# Stormwater Servicing Report

Marsfield Common

Ref: 212044  
Rev: G  
Date: 10.05.2022

## **RESPONSE TO CITY OF RYDE LETTER DATED 31 MARCH 2022**

Figure 17: Channel to divert upstream catchment

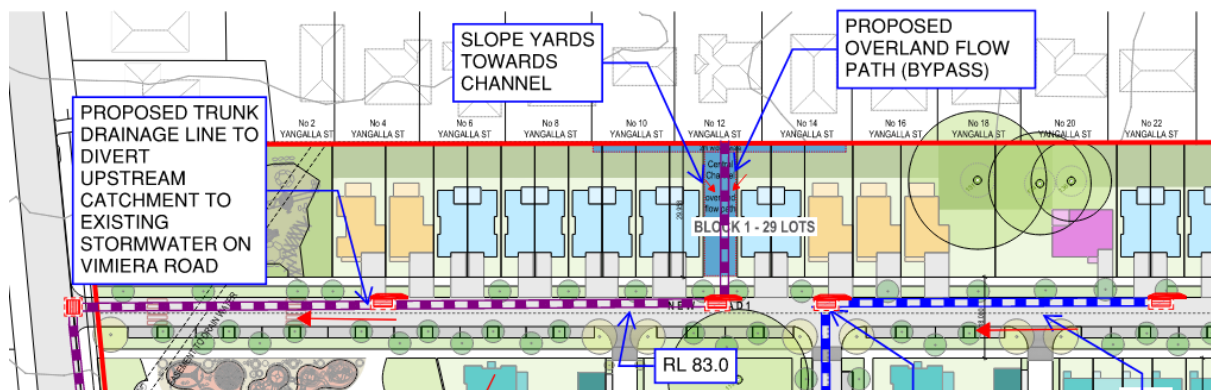
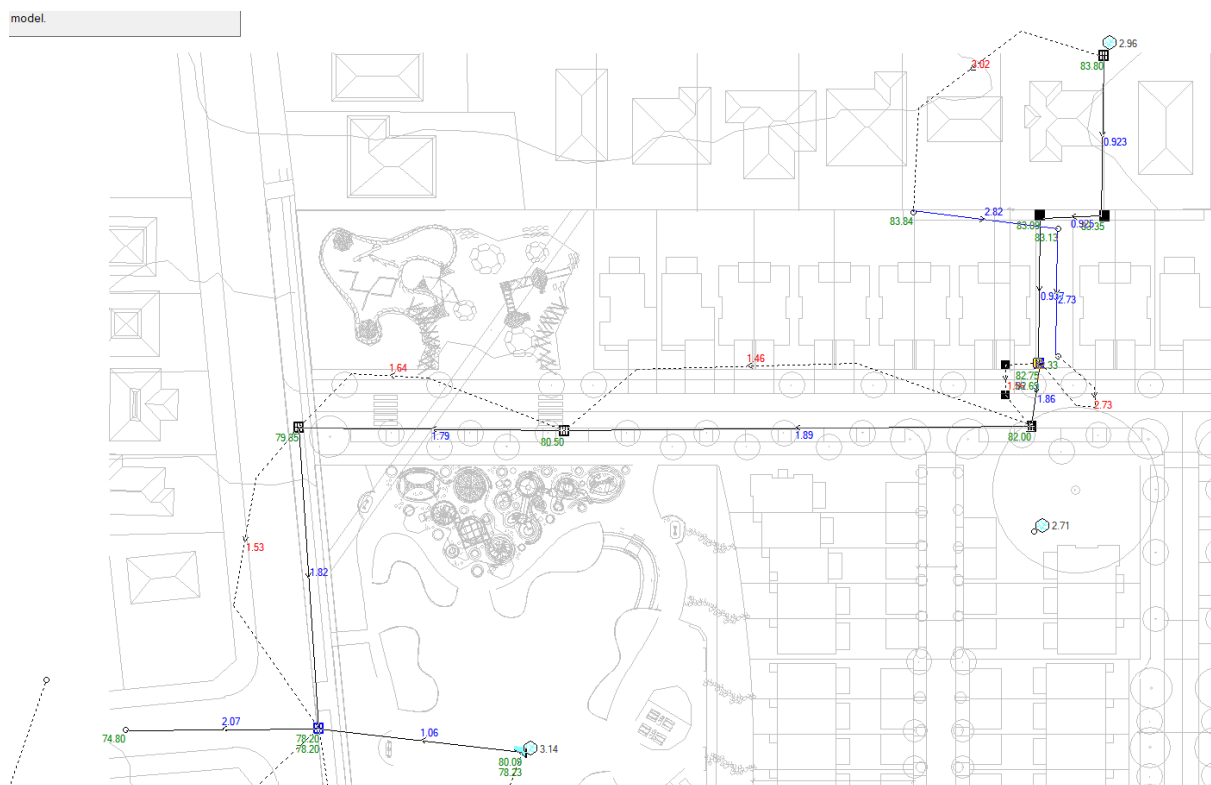
*The site is affected by an overland flow path. The proposed concentration of overland flows using concrete walls at the north-eastern side is not supported due to the potential adverse effect on the Yangalla Street properties and safety concerns. Options should be considered to address this concentration such as:*

- *Explore the construction of a stormwater pipe (with enough KIPs to collect all runoff) in Yangalla Street to collect the overland flows to ensure it does not reach the development site.*
- *If overland flows are proposed through the site, every dwelling affected by overland flow may have to be built on piers, to allow free pass of the overland flows (no concentration of flows will be supported).*

- The channel proposed at the rear of proposed properties is necessary due to the existing flow from the upstream catchment; the existing flow is between houses of multiple upstream properties and hence requires an extensive point of capture within the site.
- The channel will be completely fenced off with a locked gate.
- Flow is completely contained within the channel and will have sufficient freeboard to adjacent properties.
- During detailed design, flood modelling will be undertaken to confirm this channel has no adverse impacts to upstream properties.
- Flow from the channel over the proposed footpath is managed at safe velocity-depth ratios.
- Flow through the proposed road network is managed at safe velocity-depth ratios.

See section title "Channel for Upstream Catchment Flows" on Page 15 under Stormwater Strategy for full response and explanation. Northrop has explored the potential, through modelling, of different options to mitigate the usage of a channel through the proposed lots, such as installation of pipe in Yangalla Street. This resulted in running pipes against grade and through the crest of a road and was deemed not feasible. It was determined that the most effective solution in dealing with upstream catchment flows was to install a fenced off channel.

Figure 20: OSD Tank Plan (Site Only)

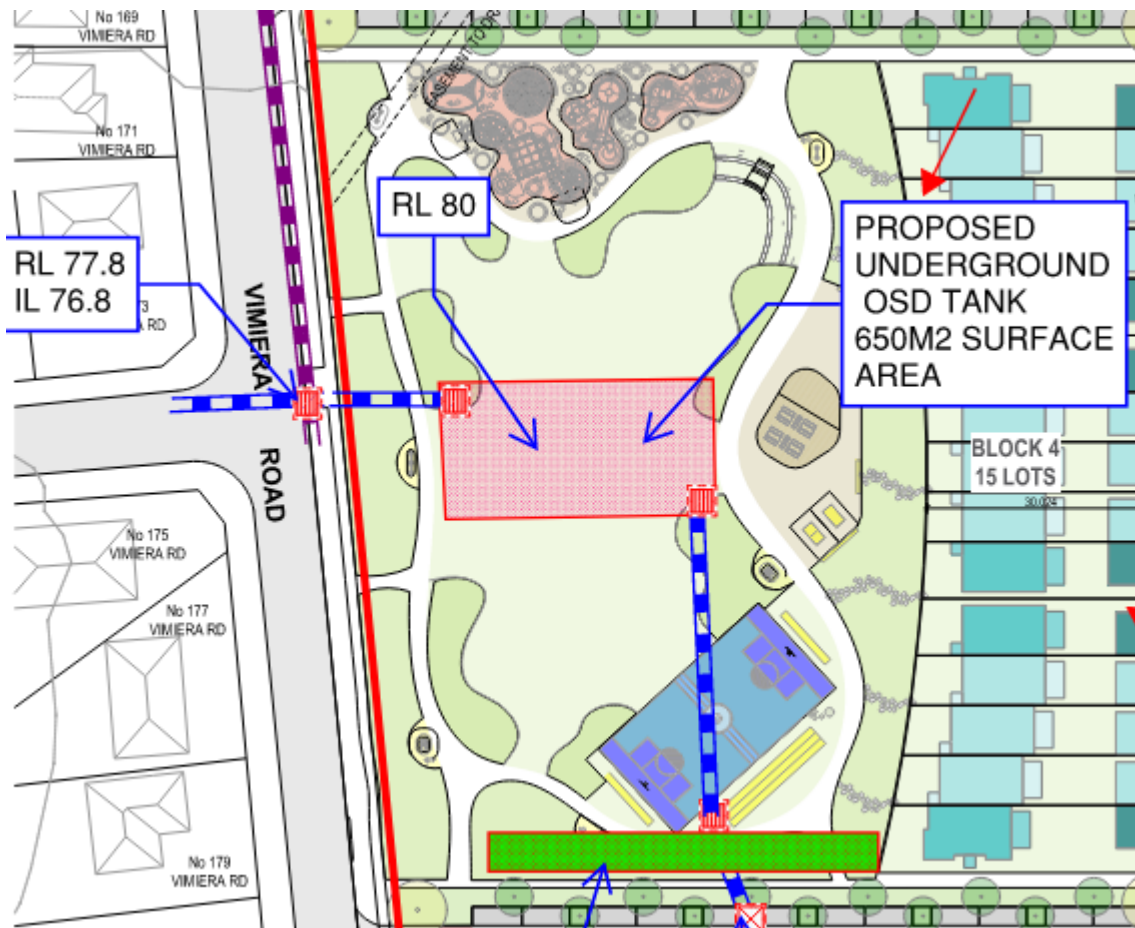
*The proposed OSD basin is not a supported solution due to safety concerns (depth, highly variable size/area of detention and frequency of inundation) and its proximity to the end of the catchment (see DCP Section 8.2, 1.4.1 d). Due to size and location of the development, consideration should be given to the upgrade of the stormwater drainage network, to allow direct discharge into the natural waterways without causing any nuisance to any neighbouring properties.*

See Section "On-site Detention Tank" on Page 17 of this report. Northrop has changed the design from a 'basin' to a 'tank' to adhere to councils comments. The tank has a surface area of approximately 650m<sup>2</sup> and is proposed to service the majority of site flows and connect into the existing drainage line along Vimiera Road. The tank has been designed to limit the post 1% AEP storm event to the existing 5% AEP.

Marsfield Common - Upstream Catchment Modelling

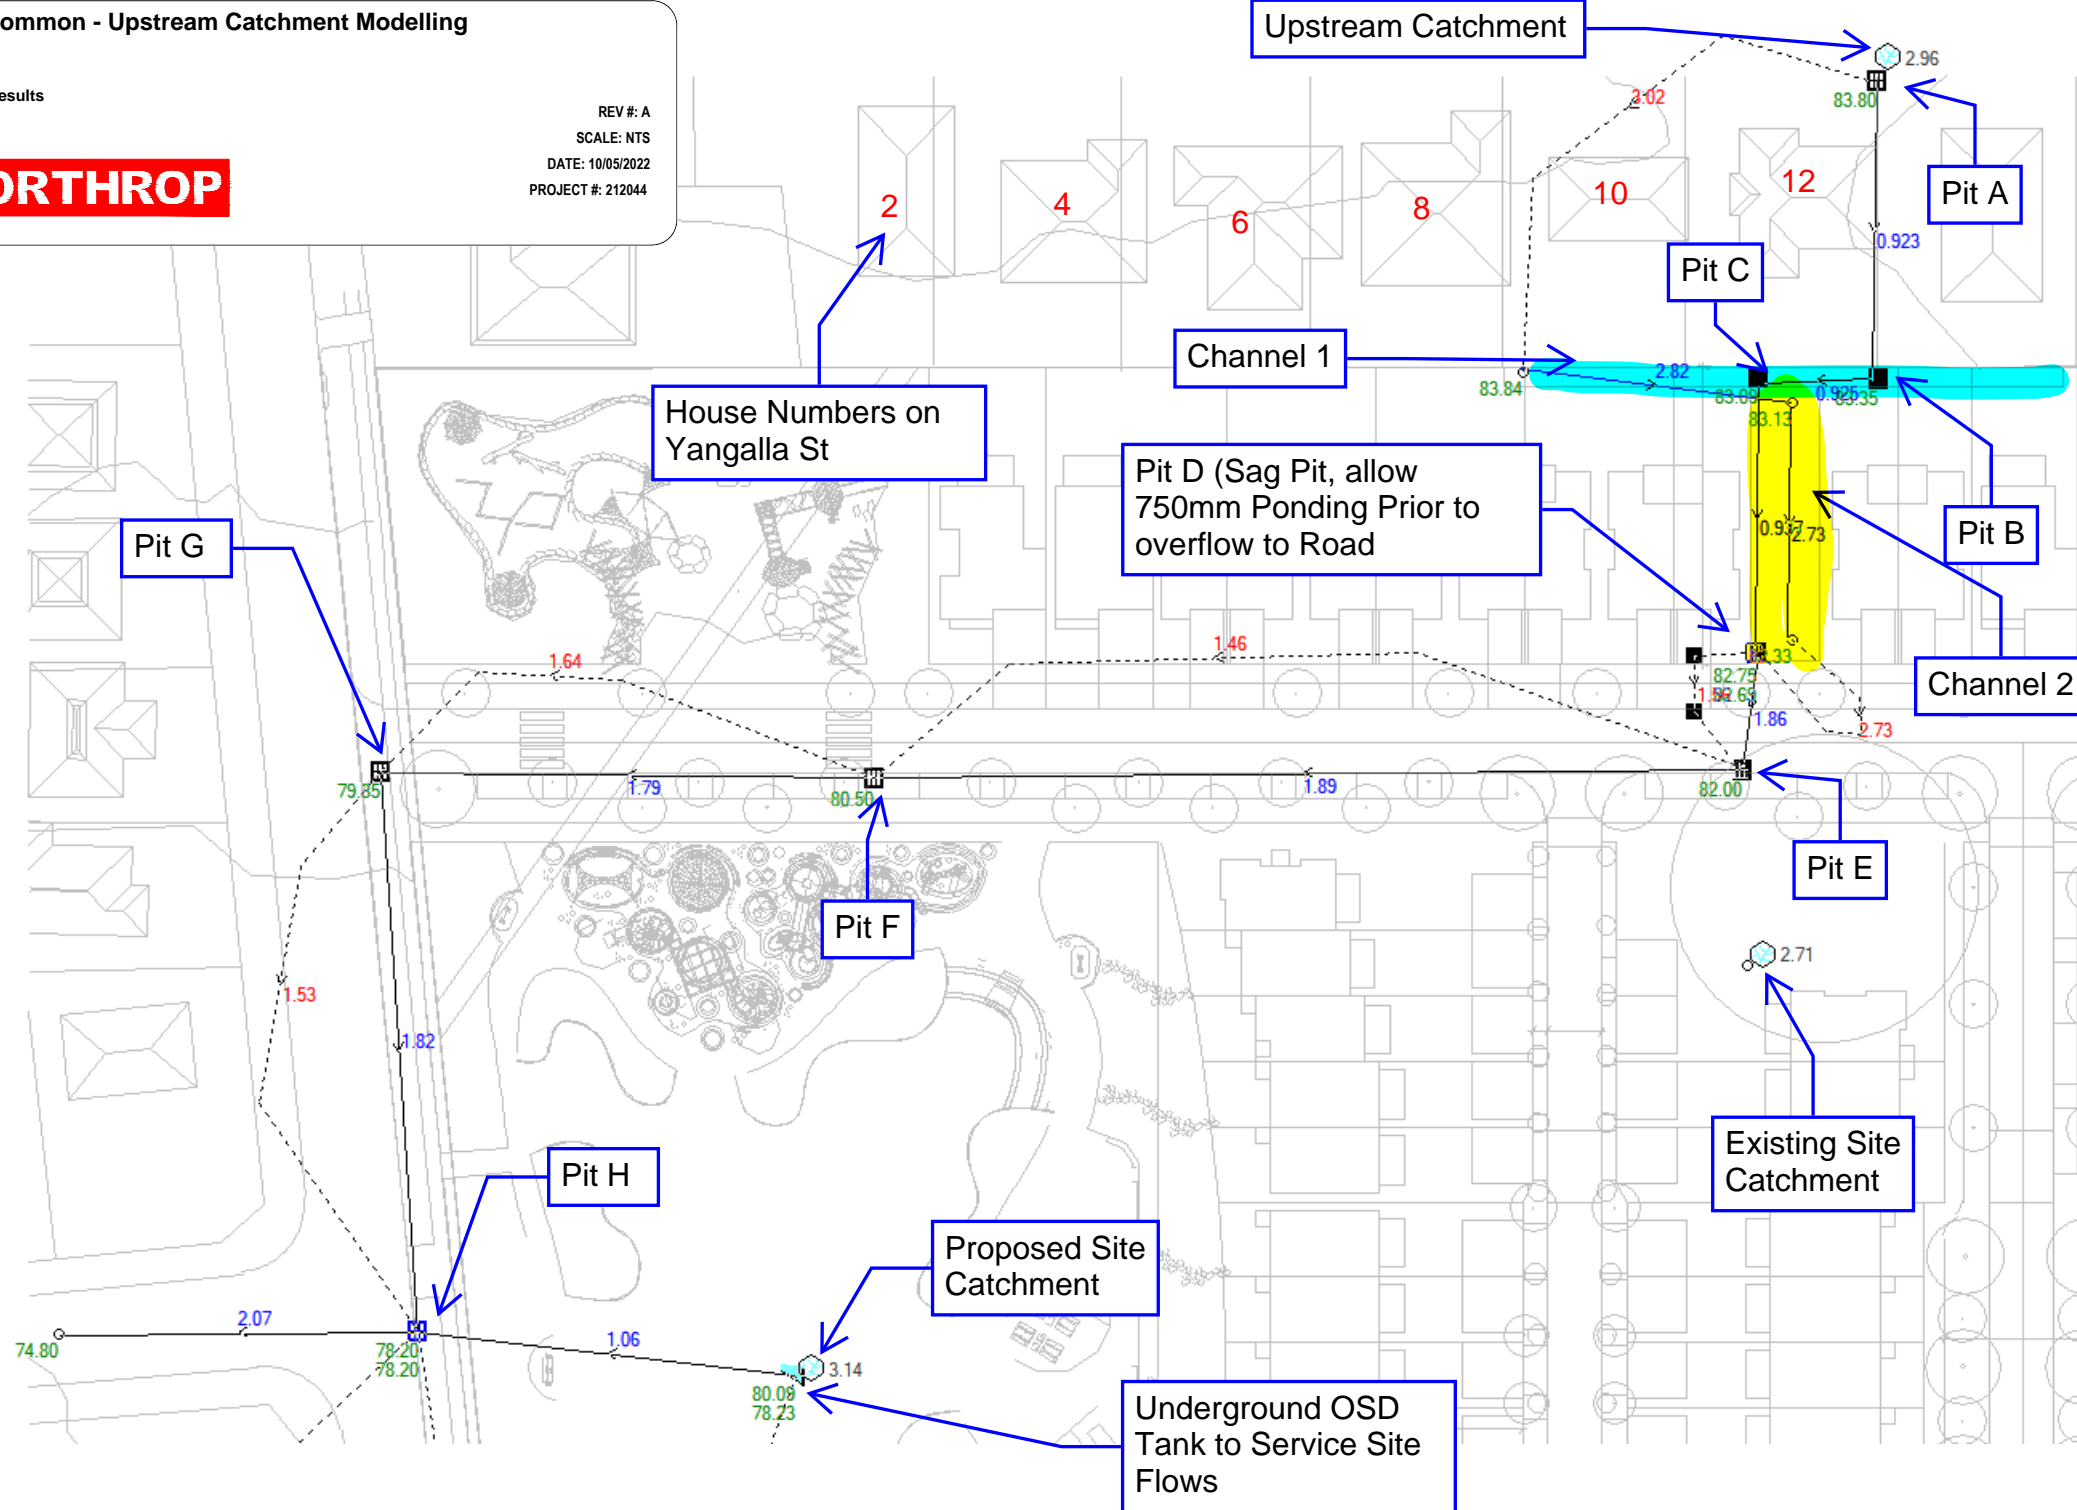
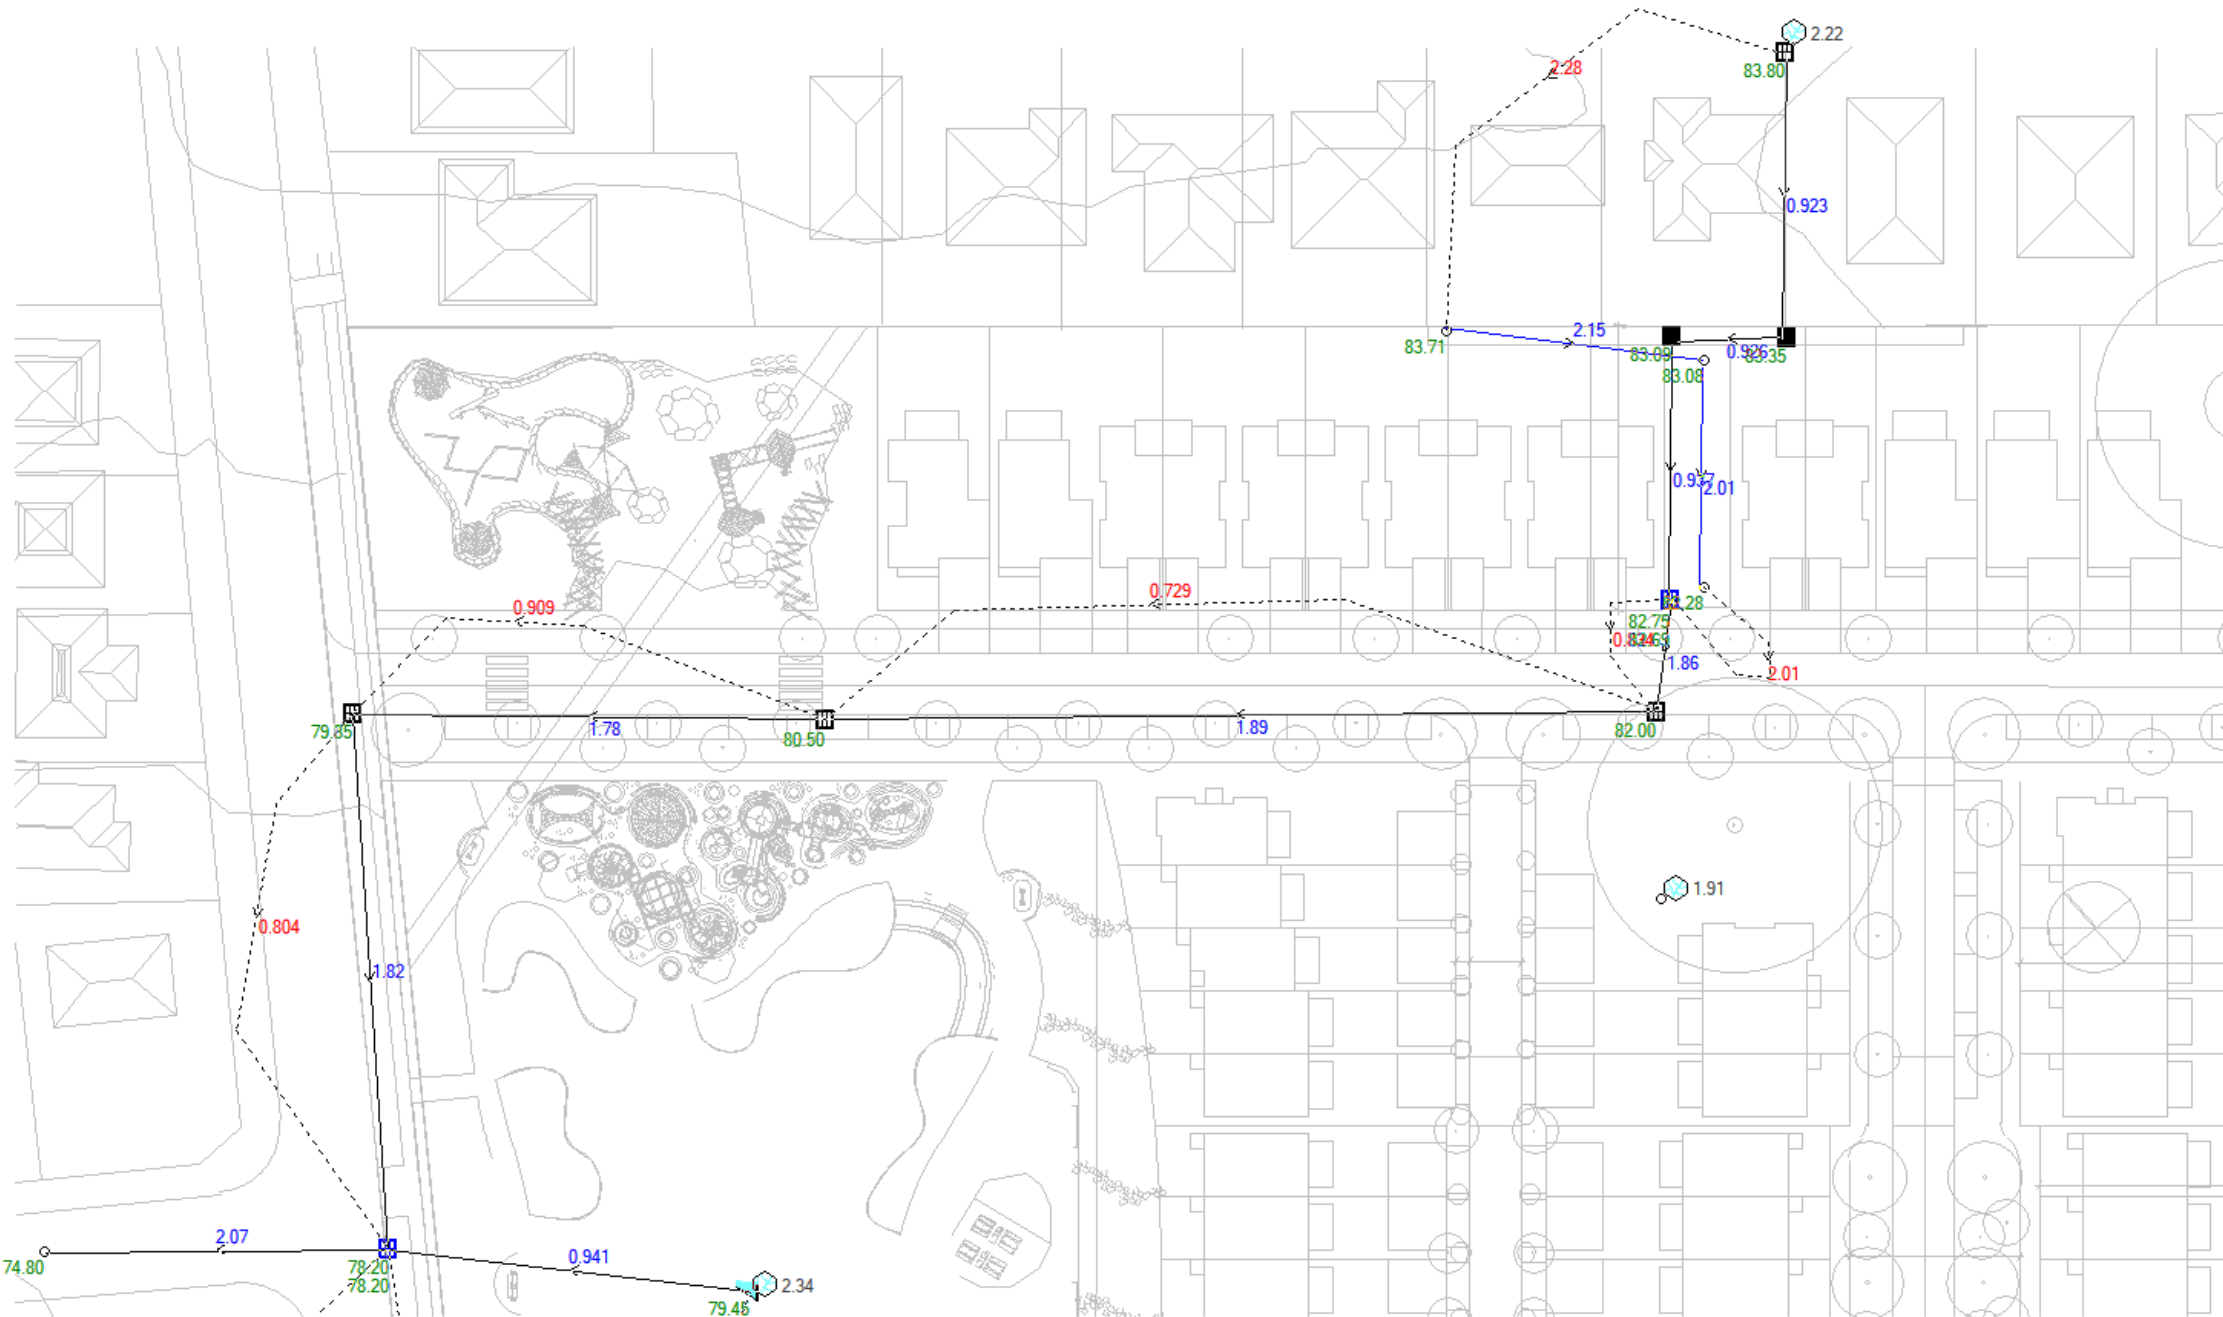
*A flood study will need to be provided with any future development application, including the effect of the new pipes in the post development scenario. The flood study will have to include all properties potentially affected by the changes in the network and pervious-impervious ratios. The preliminary work for this flood study should be considered at the planning proposal stage to provide early information to any amendments that may be required to the proposal.*

Noted, DRAINS modelling has been undertaken as part of early works, as per Appendix B.
